Re: Braun Willow Three

POADP # 716

The City Staff Development Review Committee has reviewed Braun Willow Three Master Development Plan M.D.P. (formally POADP) Preliminary Overall Area Development Plan # 716. Please find enclosed a signed copy for your files. Your plan was accepted, however, please note the following:

PRELIMINARY OVERALL AREA DEVELOPMENT PLAN
FOR
BRAUN WILLOW THREE

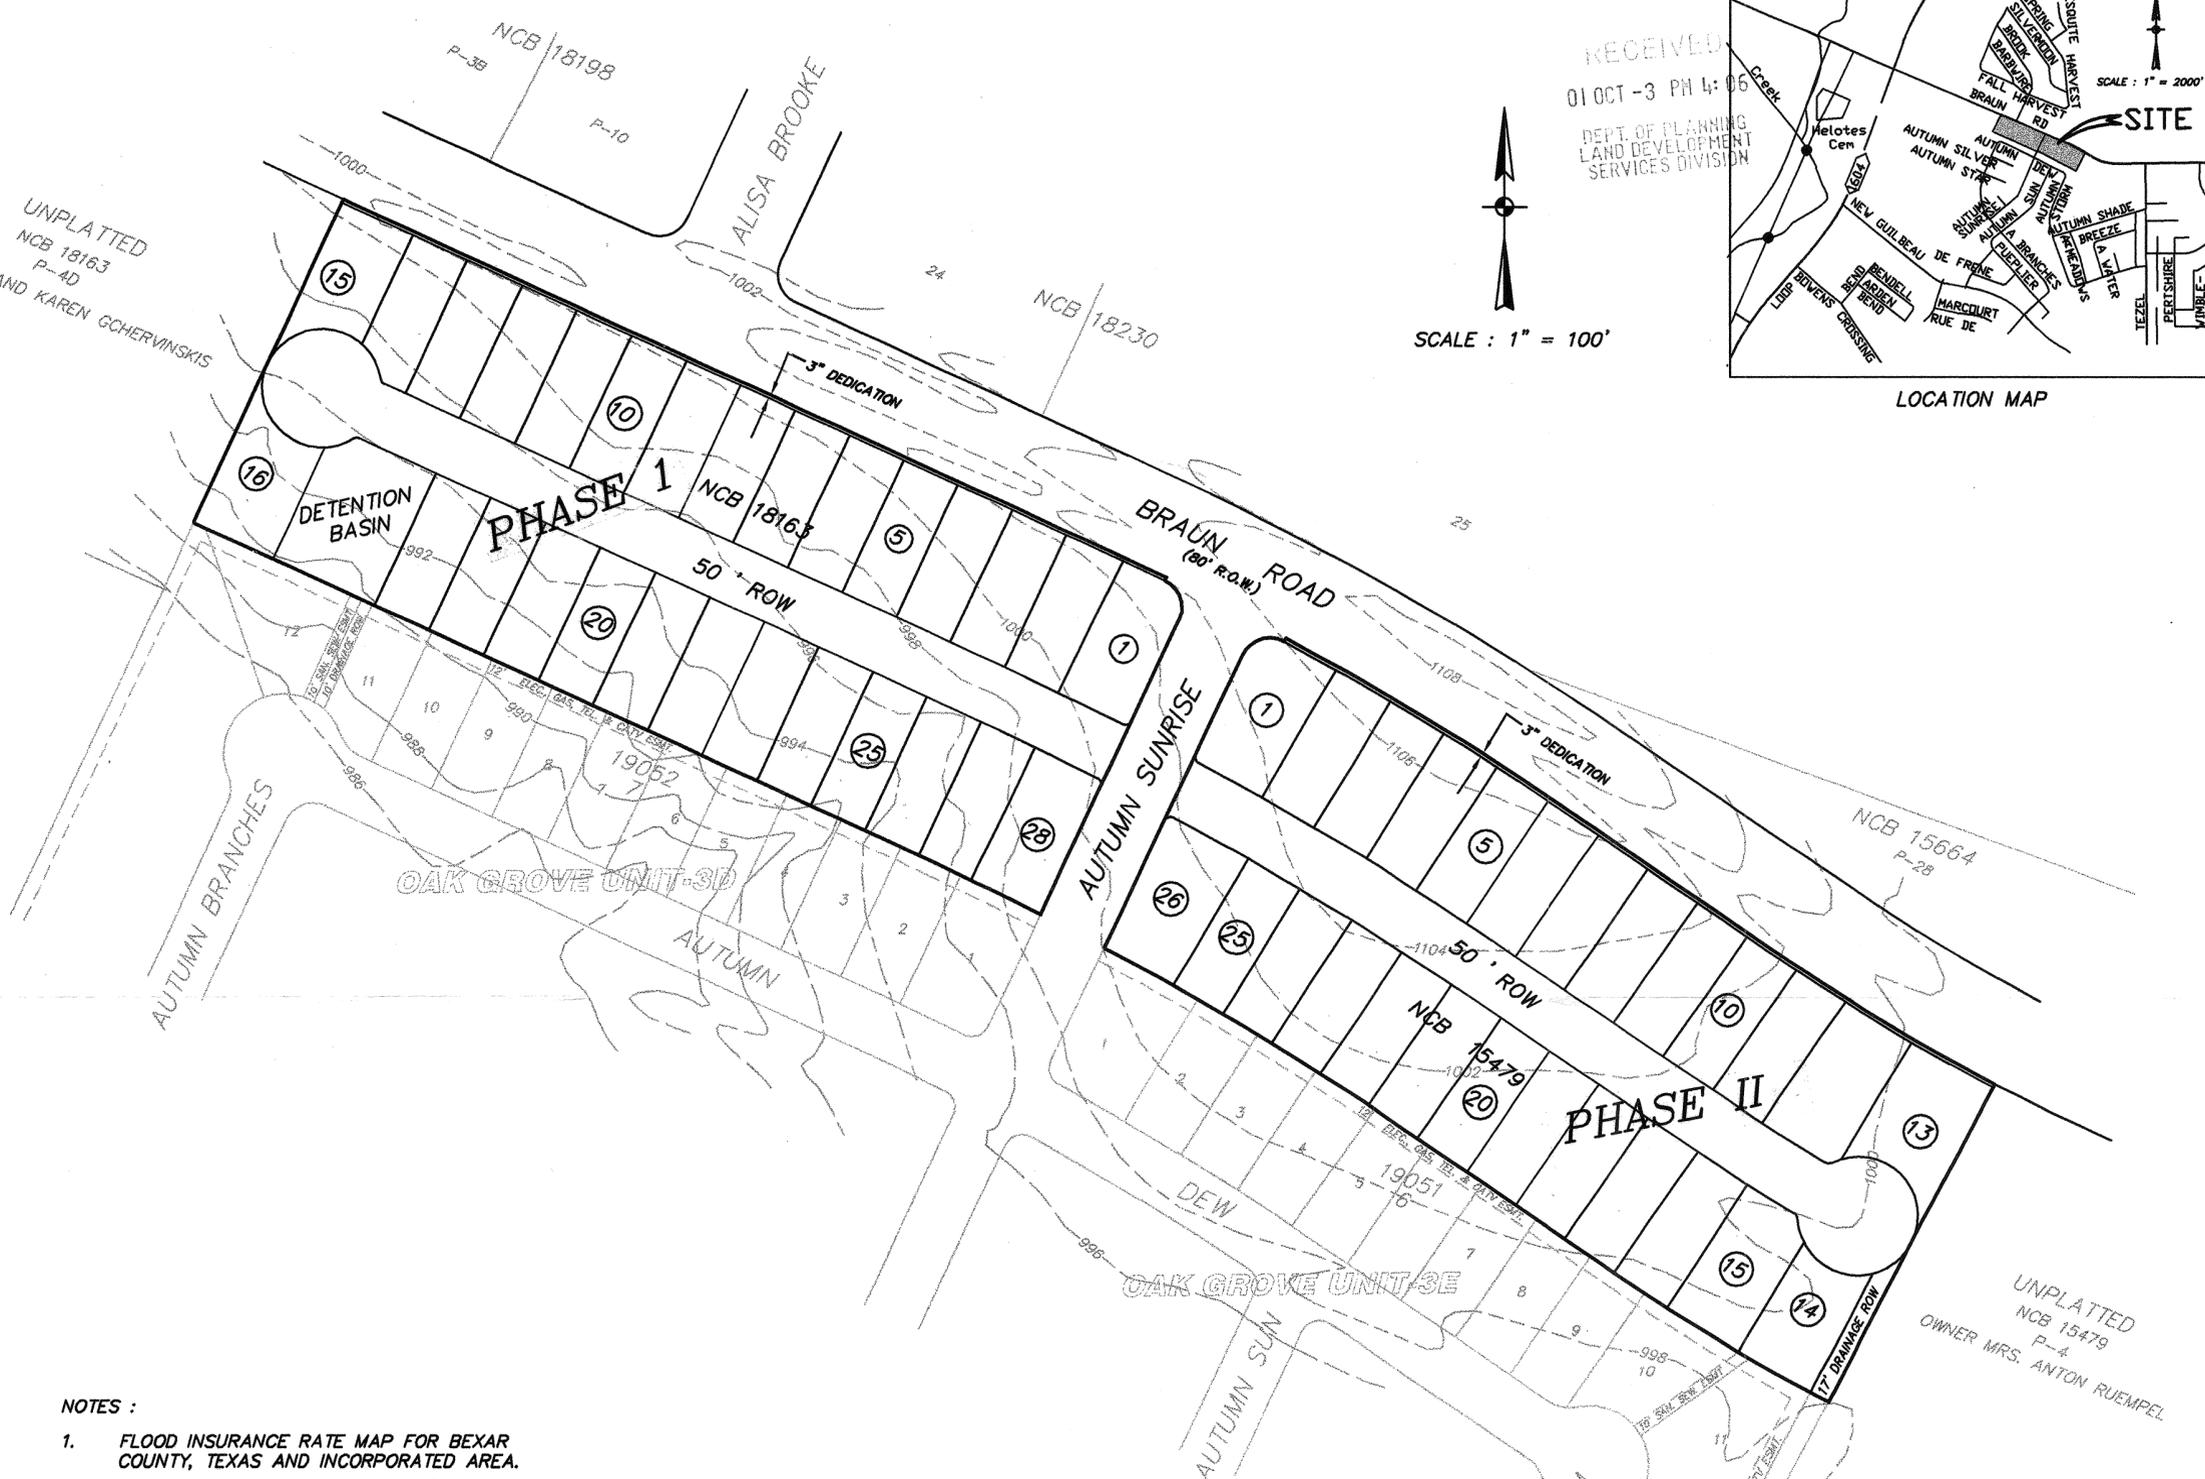
- In consideration of public safety and convenience, excessive grades by reason of topography should be avoided in street layouts and arrangements.
- Any access and R.O.W. issues along state facilities will need to be resolved with the Texas Department of Transportation (TXDOT). For information about these requirements you can contact TXDOT at 615-5814.
- This development will need to comply with tree preservation ordinance #85262. For information about these requirements you can contact Building Inspections at 207-7102.
- It will be expected that you will plat all of the property depicted in your Master Development Plan (M.D.P.) (formally POADP), to include floodplains, drainage areas and open space.
- I would encourage you to work closely with the school district, so that they can plan accordingly.
